**TOWN OF NEWBURGH
PLANNING BOARD
TECHNICAL REVIEW COMMENTS**

PROJECT NAME: NEWBURGH SELF STORAGE-1420 ROUTE 300
PROJECT NO.: 24-6
PROJECT LOCATION: SECTION 60, BLOCK 3, LOT 22.222/1420 Route 300
REVIEW DATE: 26 JULY 2024
MEETING DATE: 1 AUGUST 2024
PROJECT REPRESENTATIVE: COLLIERS ENGINEERING/JUSTIN DATES, RLA

Newburgh Self-Storage - 1420 Route 300

Below please find our responses to comments received from MHE Engineering dated June 14, 2024. The comments have been repeated here for clarity:

SHEET NUMBER:
C-3.0

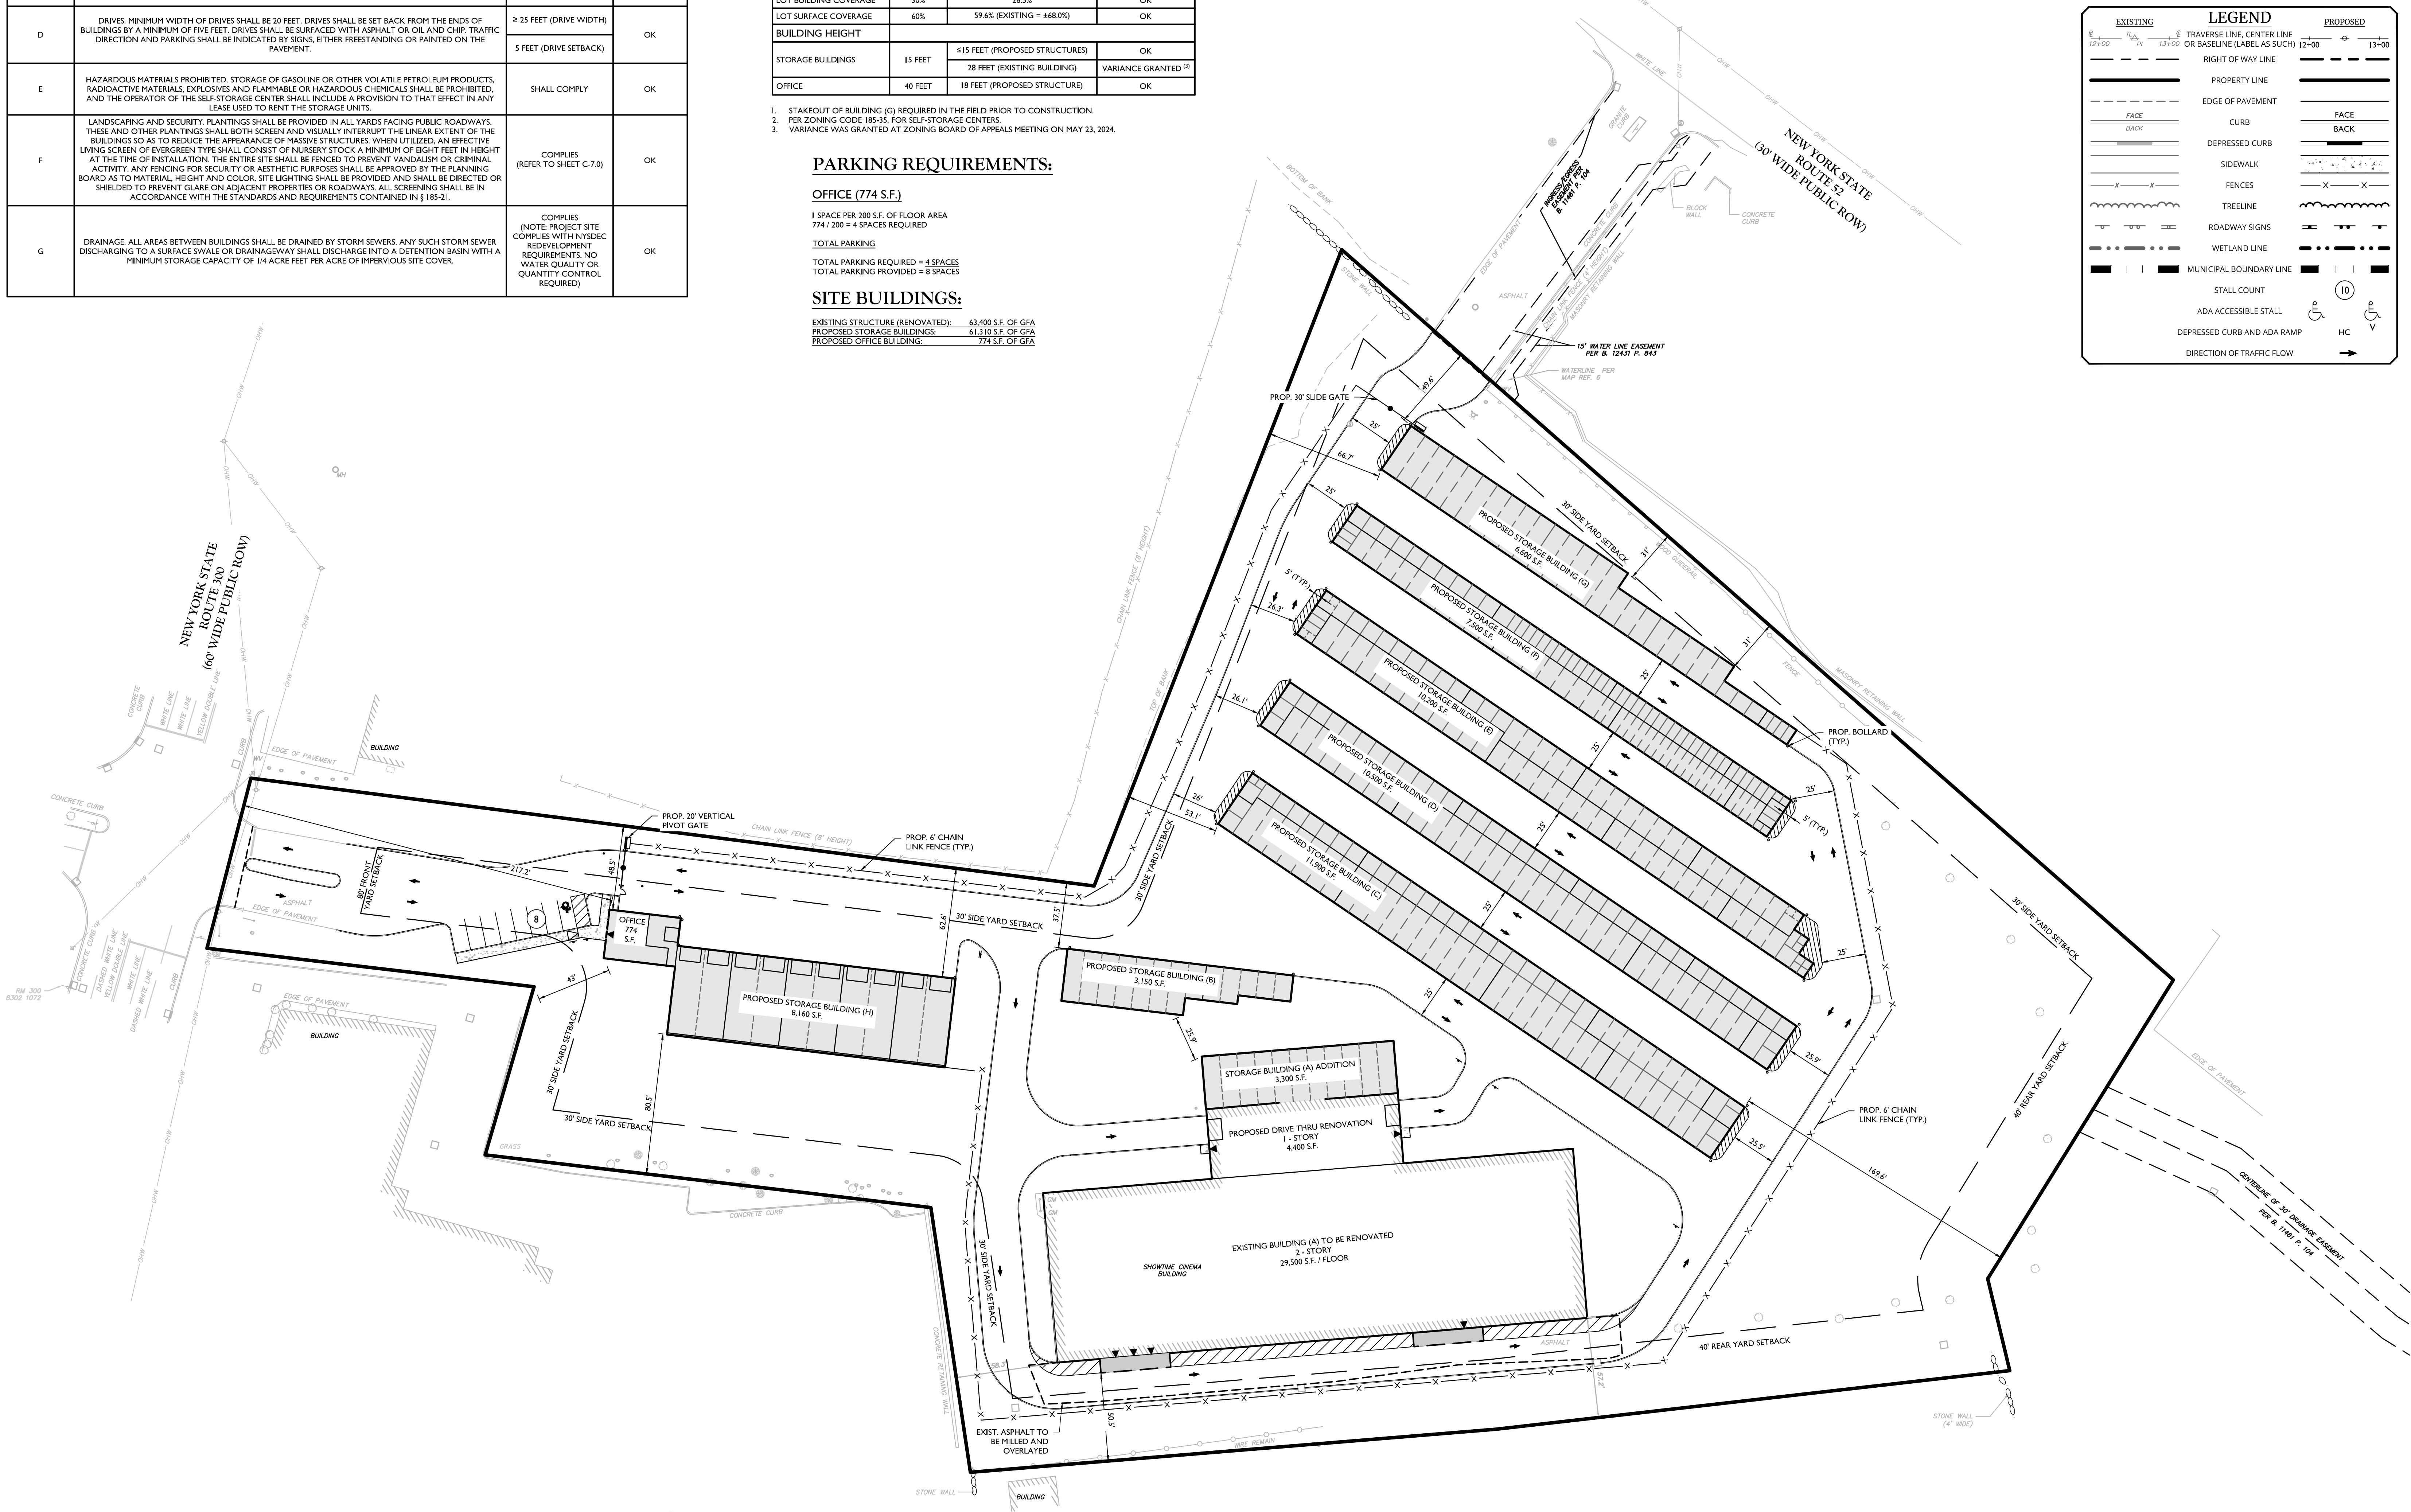
Comment 6: The northerly most structure on the site, a 6,600 square foot storage building continues to be located 1 foot off the side yard setback. Note requiring stakeout of that structure in the field prior to construction should be placed on the plans.

Comment 8: All sections of 185-35 Self Storage Centers A thru G should be specifically addressed.

Comment 9: Dimensions between buildings should be labeled to assure 25 foot separation between buildings exists.

Response 6: As requested, the above note requiring stakeout has been added to the bulk table on the Overall Dimension Plan on Sheet C-3.0.

Response 8: As requested, a table identifying the Self-Storage Center requirements from §185-35 has been added to the Overall Dimension Plan on Sheet C-3.0.

Response 9: Additional dimensions between buildings have been added to the Dimension Plans to confirm compliance with the 25-foot minimum separation, see Sheets C-3.0 & C-3.1.

Colliers Engineering & Design logo and contact information. Project title: UTILITIES PLAN. Section: SECTION 60, BLOCK 3, LOT 22.222. Drawing number: 24000891A. Scale: 1" = 30'. Includes a table for revision history.

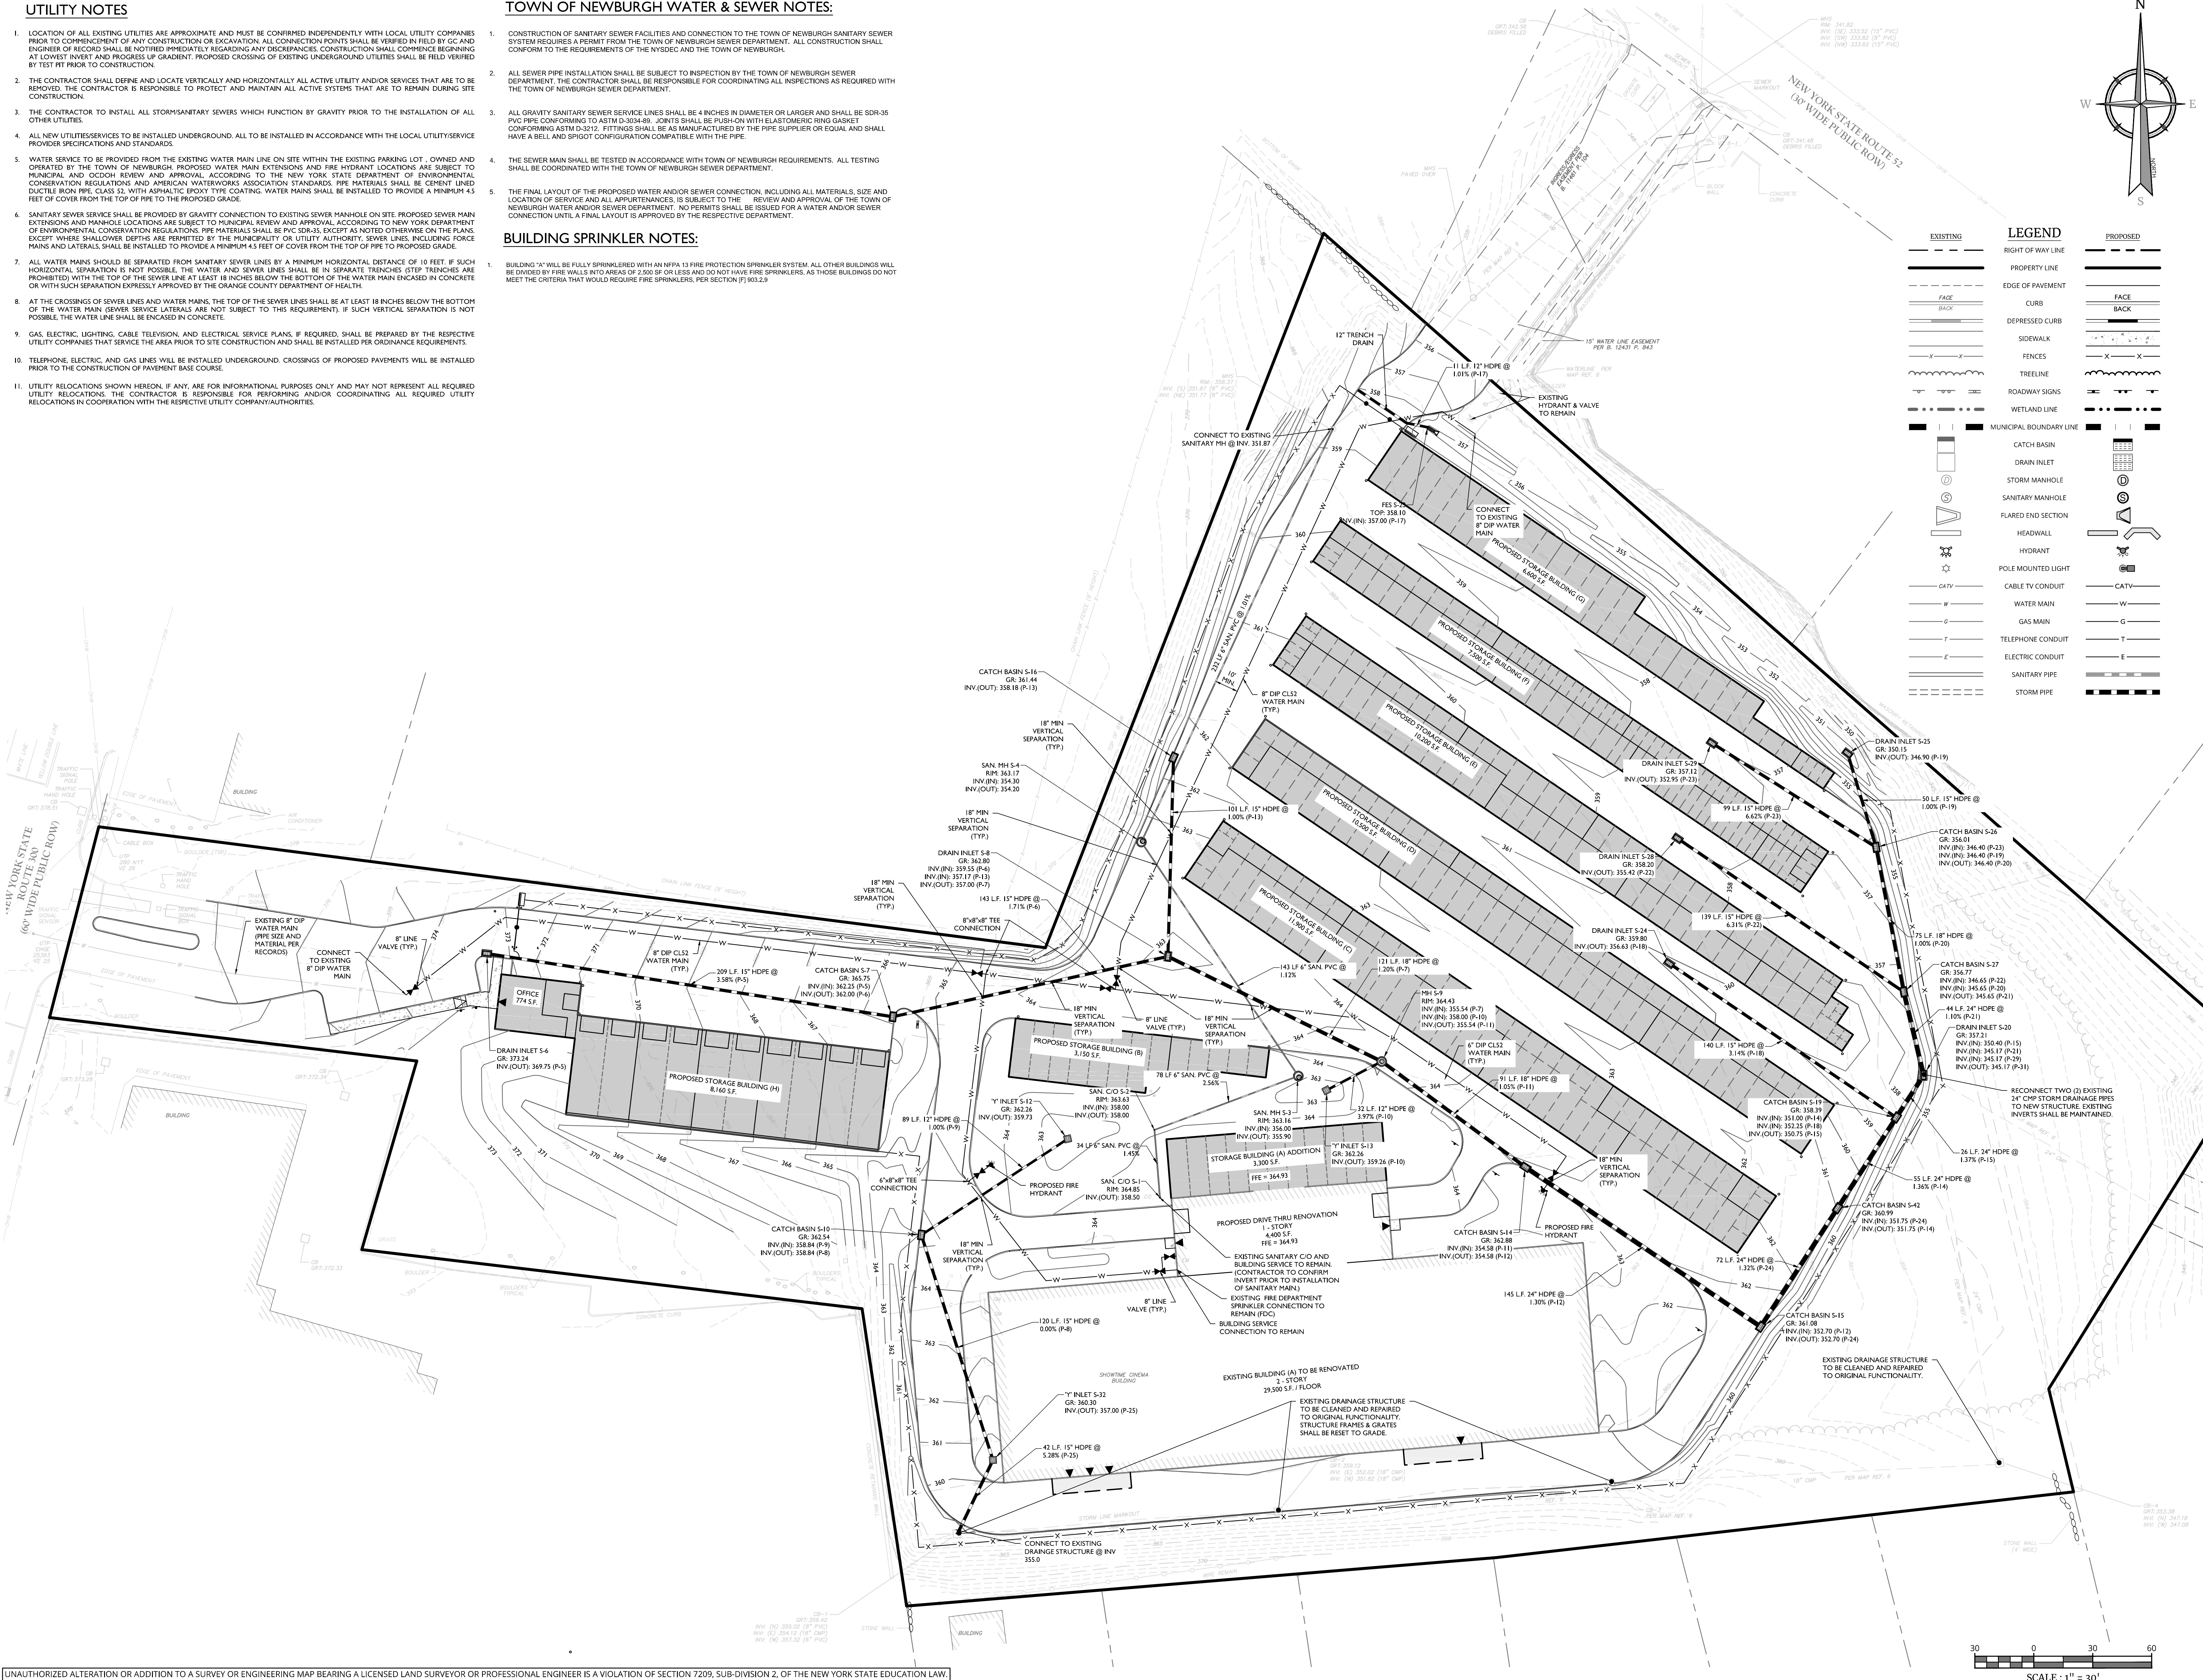
Comment 13: The sprinkler/potable water line to the self-storage structure should be installed pursuant to Town of Newburgh requirements. A sprinkler/potable water detail has been provided. (See attached)

Response 13: The water service to the existing building has been modified per the above comment, refer to Sheet C-5.0.
